DEVELOPMENT NO.:	25039869
APPLICANT:	Thomas Treloar
ADDRESS:	18 GULF PDE SOUTH BRIGHTON SA 5048
NATURE OF DEVELOPMENT:	Variation to DA 24038084 (Variation of Development Application 24036704 to add rooftop terrace to each dwelling and additional screening the rear upper level balcony and rooftop terrace) comprising changes to the height of balcony and roof top screens
ZONING INFORMATION:	<p>Zones:</p> <ul style="list-style-type: none"> • General Neighbourhood <p>Overlays:</p> <ul style="list-style-type: none"> • Urban Tree Canopy • Airport Building Heights (Regulated) • Affordable Housing • Prescribed Wells Area • Regulated and Significant Tree • Stormwater Management • Signif Retirement Facility Supported Accom Sites
LODGEMENT DATE:	23 Dec 2025
RELEVANT AUTHORITY:	Assessment panel at City of Holdfast Bay
PLANNING & DESIGN CODE VERSION:	P&D Code (in effect) Version 2025.22 18/12/2025
CATEGORY OF DEVELOPMENT:	Code Assessed - Performance Assessed

The proposal is a variation to DA 24038084 (Variation of Development Application 24036704 to add rooftop terrace to each dwelling and additional screening the rear upper level balcony and rooftop terrace) comprising changes to the height of

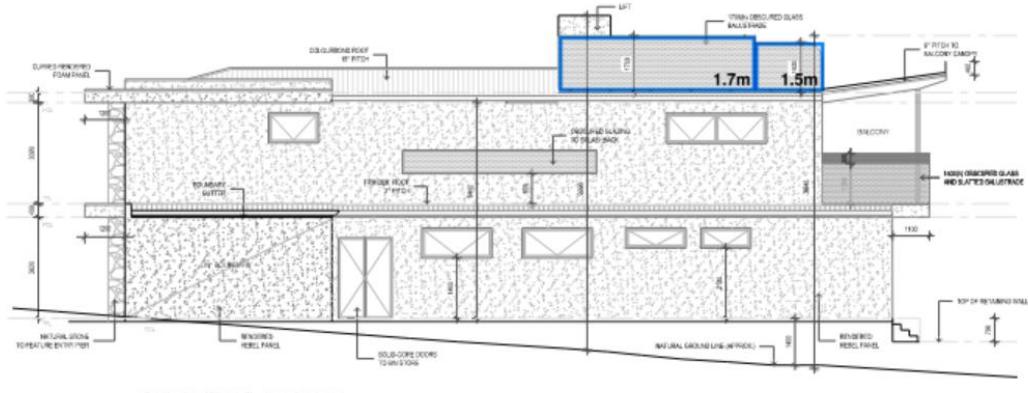
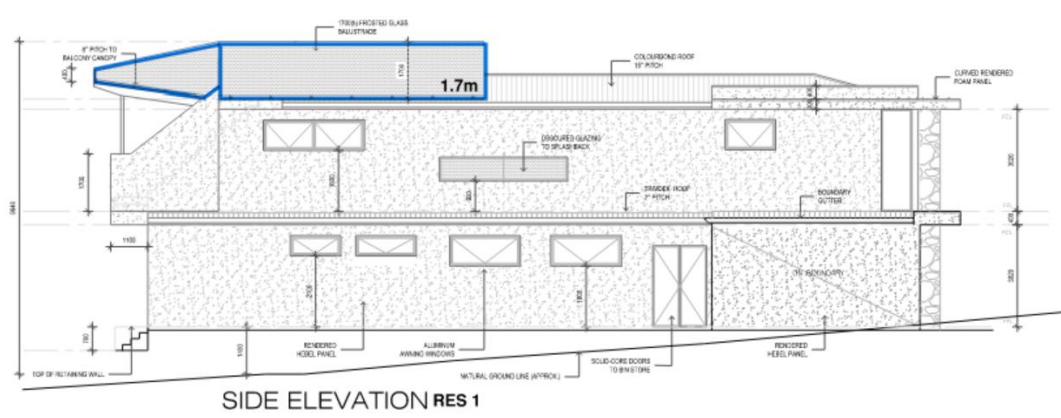
- a combination of 1.5 to 1.7 metres in height to the sides of the rear balconies and roof tops;

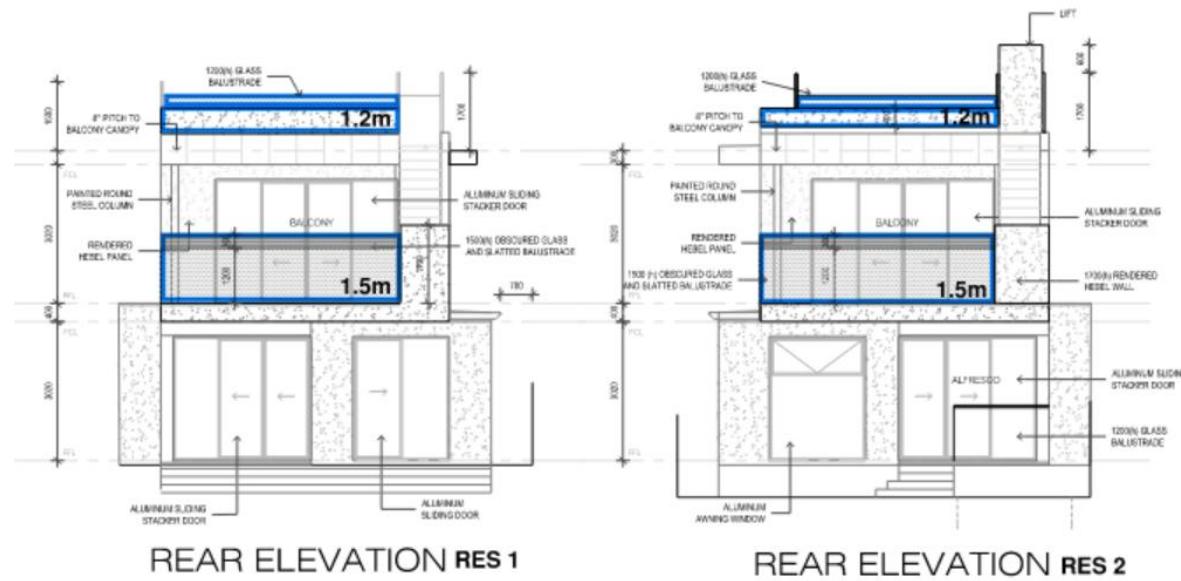
- screening to a height of 1.5 metres on the western rear elevation of the second level balconies; and
- screening to a height of 1.2 metres on the western rear elevation of the roof top terraces.

Above: Aerial image of 180 Esplanade South Brighton

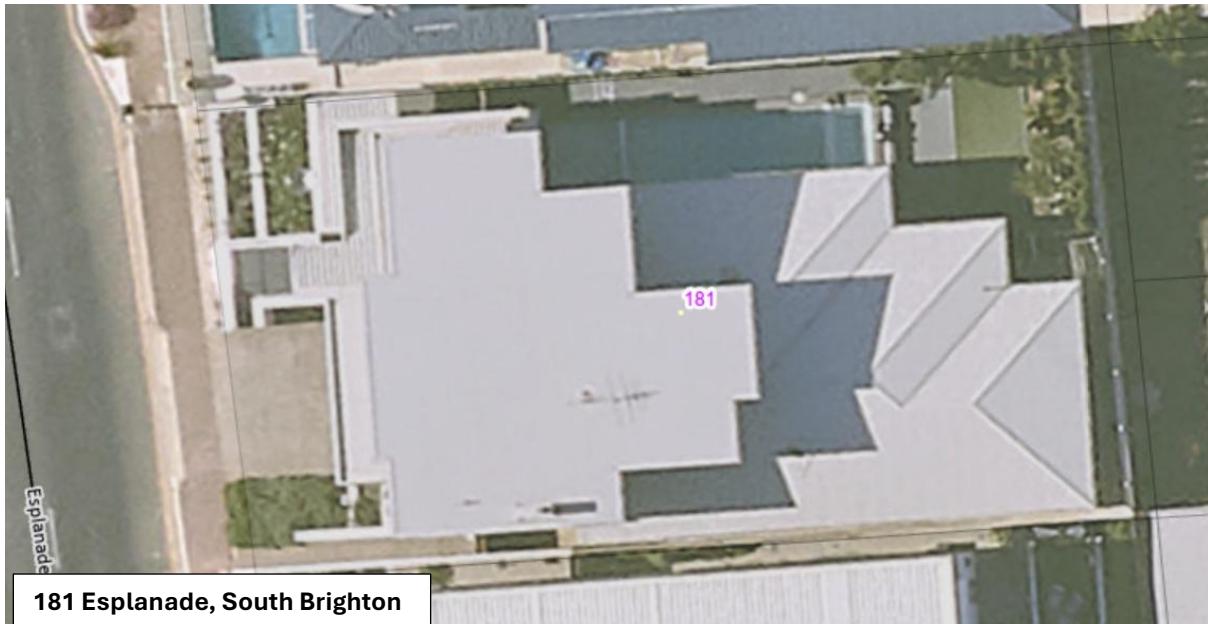
The dwelling located directly to the west of the subject land, 180 Esplanade, contains its useable outdoor areas to the front where a swimming pool and front verandah/ balconies are located. The rear of the property contains a garage and a driveway which functions more as an access area for vehicles as opposed to an area of private amenity. The rear upper-level windows of 180 Esplanade contain obscured glazing to appropriate heights therefore no overlooking will occur into habitable room windows.

Above: 15m radius of overlooking from the rear balconies

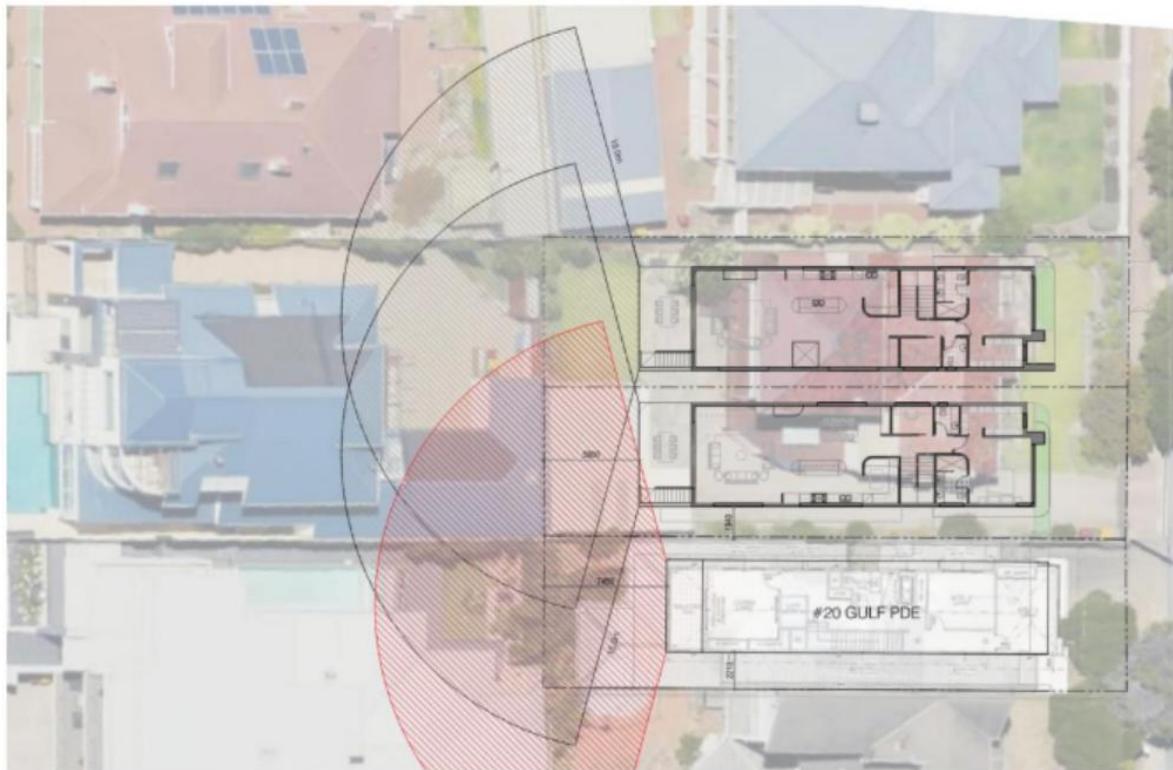
The viewing diagram below also shows the extent of views from the dwelling under construction at 20 Gulf Parade which contains a 1.5m high balustrade.

The submitted overlooking diagrams illustrate that portions of the rear yard at 181 Esplanade may be subject to overlooking from the proposed development.

The proposed screen height of 1.5 metres at the second level west facing balcony is considered reasonable, as it satisfies Performance Outcome 10.2:

A screen height of 1.5 metres is typically considered to be reasonable in mitigating direct overlooking into neighbouring land, evident by the fact that upper level windows require a minimum height of 1.5 metres. Both an upper level window and balcony offer a similar vantage point (i.e. same floor level) with the only point of difference is that one element is enclosed and the other is open.

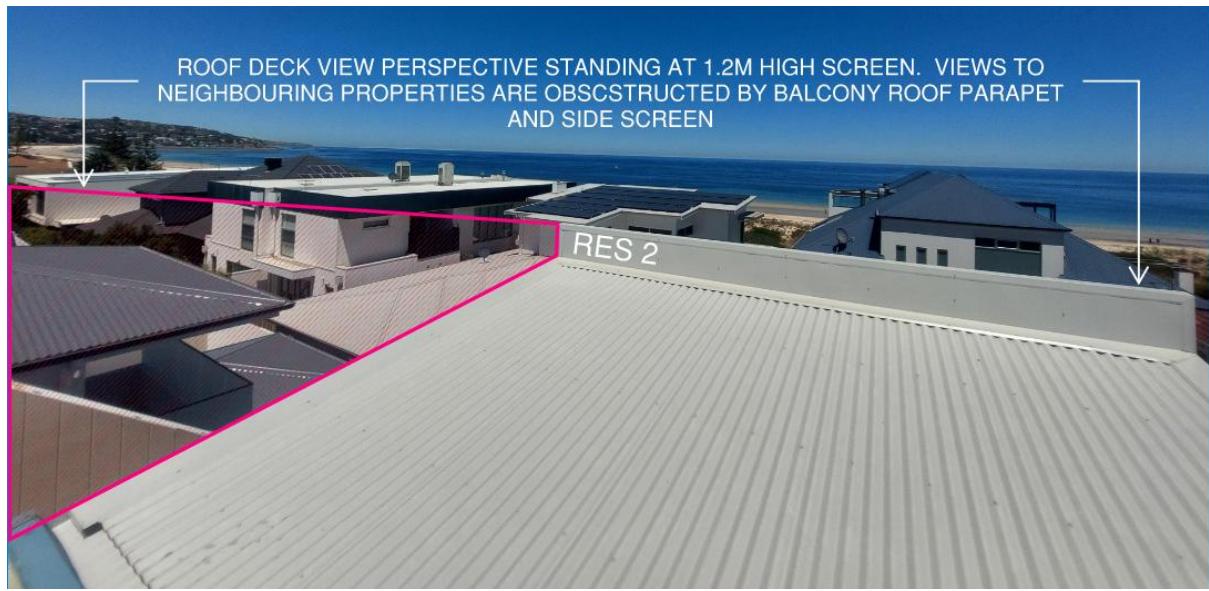
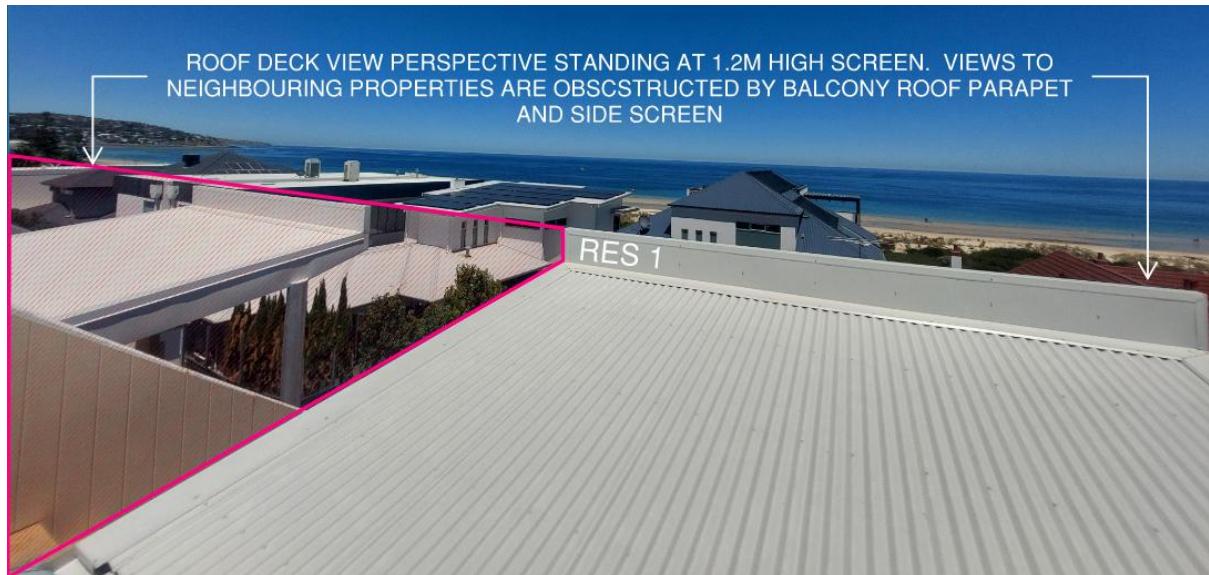
Regarding the roof top deck screening, which comprises a screen height of 1.2 metres on the western rear elevation and screening between 1.5 and 1.7 metres in height to the sides, which tapers down to the height of the 400mm high second level balcony roof parapet. A site inspection was undertaken from the roof deck as part of the assessment process to which it was practically determined that the proposed roof deck screening is sufficient due to the existence of the second level balcony roof below, which protrudes beyond the 1.2 metre screen. The physical viewing point, together with the actual sight lines are such that the proposed side screens and second level balcony roof are sufficient in preventing direct views into neighbouring properties.

This is illustrated in the photographs below, which demonstrate the line of sight standing at the location of the 1.2 metre high screening. A pink coloured outline is added to the photo to demonstrate the surface area of the proposed screen, which clearly prevents views into neighbouring yards or windows.

Based on the applicants well designed screening, the roof deck is also considered to satisfy Performance Outcome 10.2 in that the development mitigates direct overlooking from balconies to habitable rooms and private open space of adjoining residential uses in neighbourhood type zones.
